Seabrook Station
Emergency Response Manual ER5.3, Rev. 18, Chg. 01

**SEABROOK STATION
ADMINISTRATIVE PROCEDURE**

Operation of the METPAC System

Rev. 18 Chg. 01

Figure 8
METPAC Data Entry Screen Guidance
 (Sheet 1 of 16)

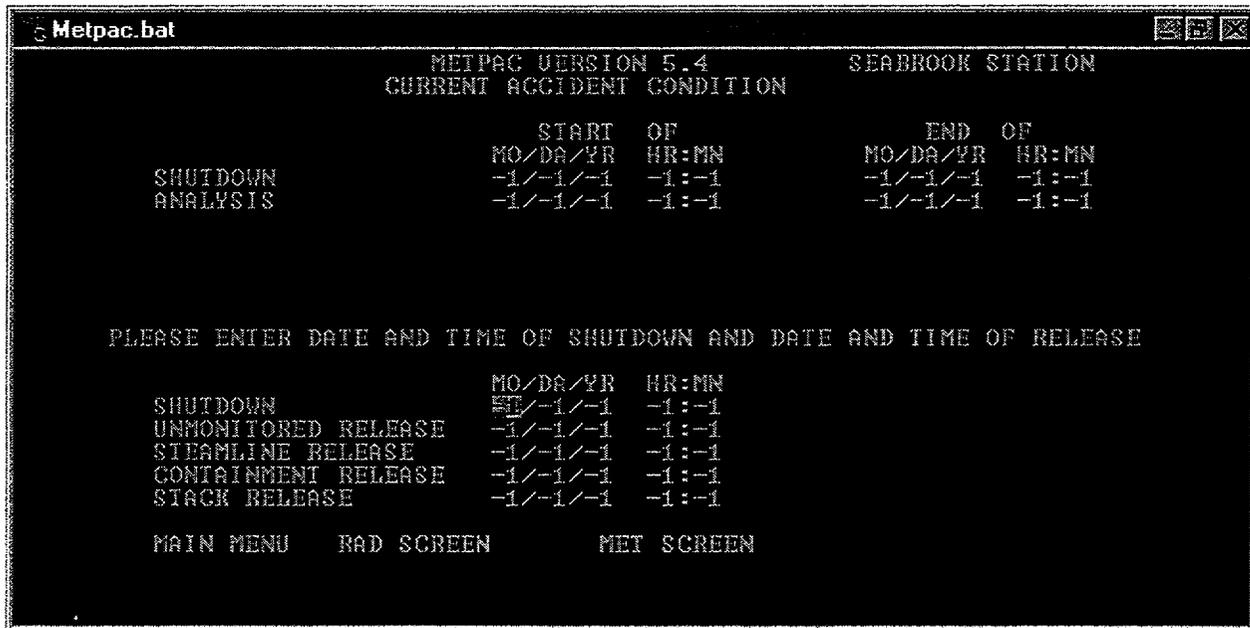
Added Figure 8, METPAC Data Entry Screen Guidance. Renumbered old Figure 8.

Figure 9 METPAC Function Key Listing (Sheet 1 of 3)

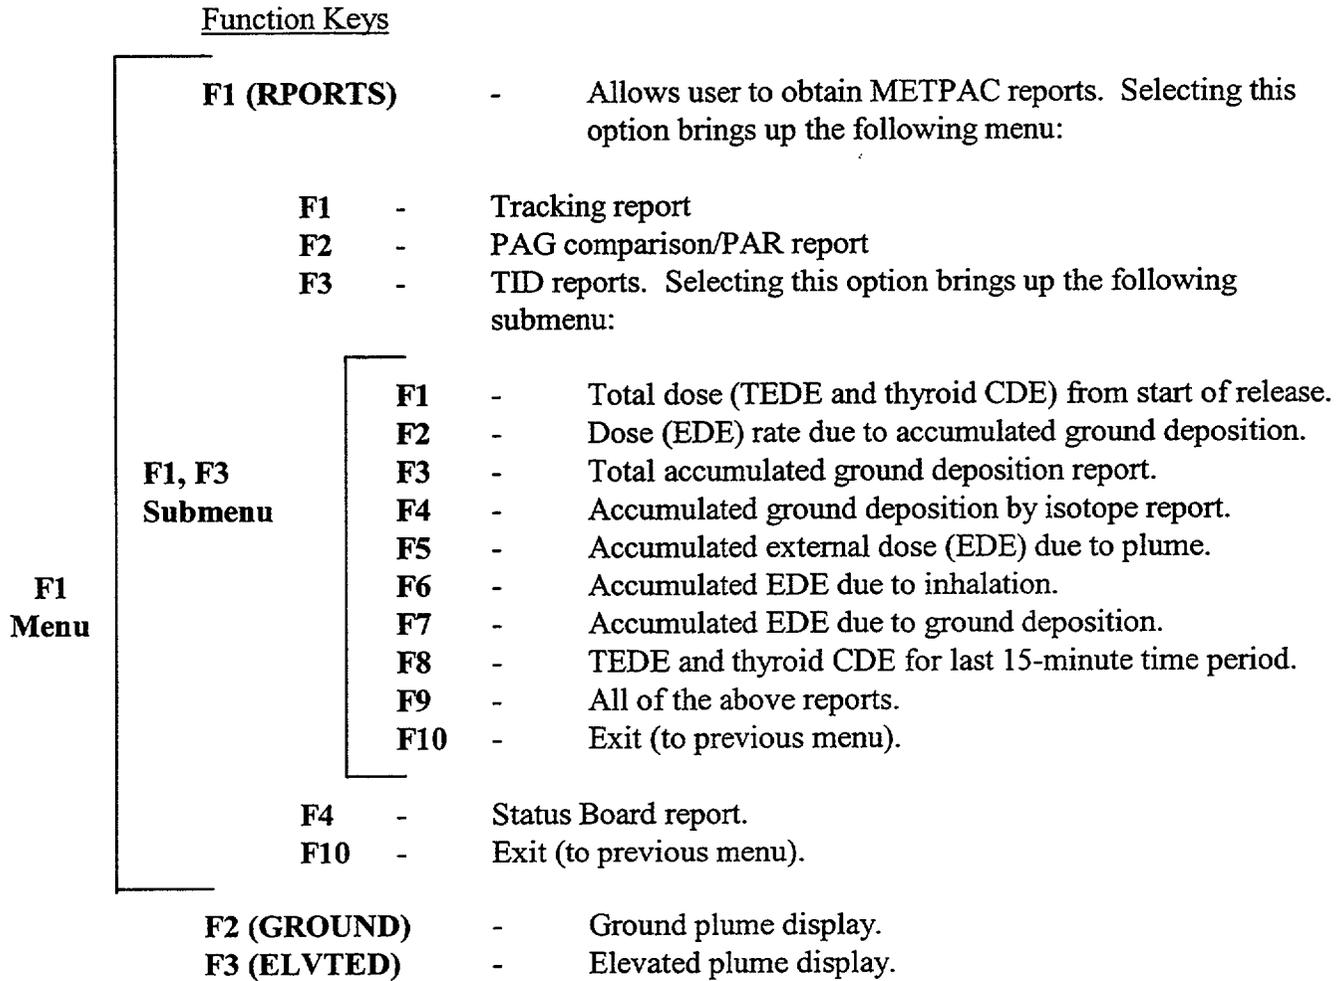
In §5.1, step 1, changed IPT to INGEST. In step 8, added references to Figures 8 and 9. Deleted Note and steps 9 through 12. Relocated the description of Function Keys to Figure 9.
